RE: PLA-2026-000731 - Old Hall Drive Academy, Old Hall Drive, Gorton & Abbey Hey ward

Re: Installation of 2.4m high fence following removal of existing low level fencing and gates

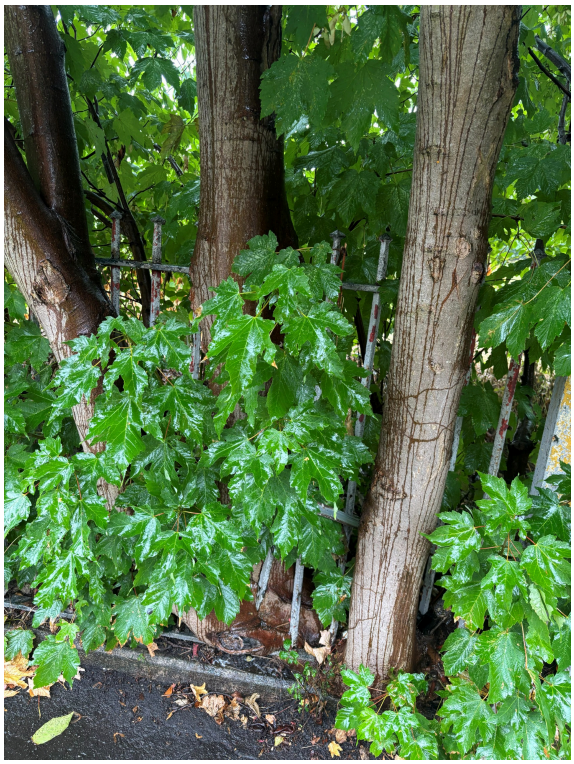
***Photo 1 and 2** shows smaller self-seeded broadleaf trees growing directly adjacent to the existing fence line. It is anticipated that approximately 5-10 of these will require either removal or cutting back where necessary to facilitate the installation of the replacement fence.*

***Photo 3 and 4** shows the only affected larger established tree's that are located immediately adjacent to the existing boundary. These tree's will require removal due to the proposed location of the new fence line.*
